NHTSA Recall Identification Number: 11V131

SAFETY RECALL NOTICE – Carrier GenV EM-1 Evaporator Unit, component used on certain Ford E-350 Conversions manufactured by The Braun Corporation (Model years 2005-2011)

TAC-SER11-001
01-31-11

Subject: EM1 Gen V Evaporator Units

Serial Number Tag

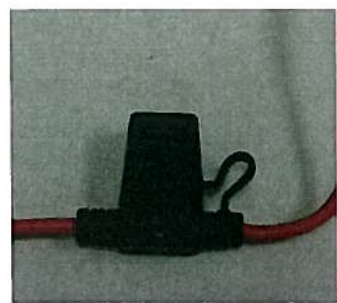
- 2) Once the cover has been removed, the identification tag containing the unit part number, manufacture date, and serial number can be found on the motor "cradle" mount, as seen in the photo below (on left). Compare the information to the above mentioned manufacture date, and/or serial number. Units employing a fuse holder as appears circled in red below require the upgrade with the new fuse holder.

Old Fuse Holder

New Fuse Holder

The EM1 GenV blower motor fuse assembly could fail in an unsafe manner, creating a potential fire hazard. We are advising that any units manufactured between January 1, 2006 and December 2010 must have the evaporator motor in-line fuse assembly upgraded with the retrofit kit 74-62056-00. The only units affected are EM1 GenV evaporator modules, part numbers 77-62512-XX and 77-62112-XX, with serial numbers between KNT90890232 and NNE91230058. Customers with EM1 GenV units prior to the above mentioned serial numbers and dates that have had Carrier replacement motors 54-00621-00 installed, will also require this upgrade.
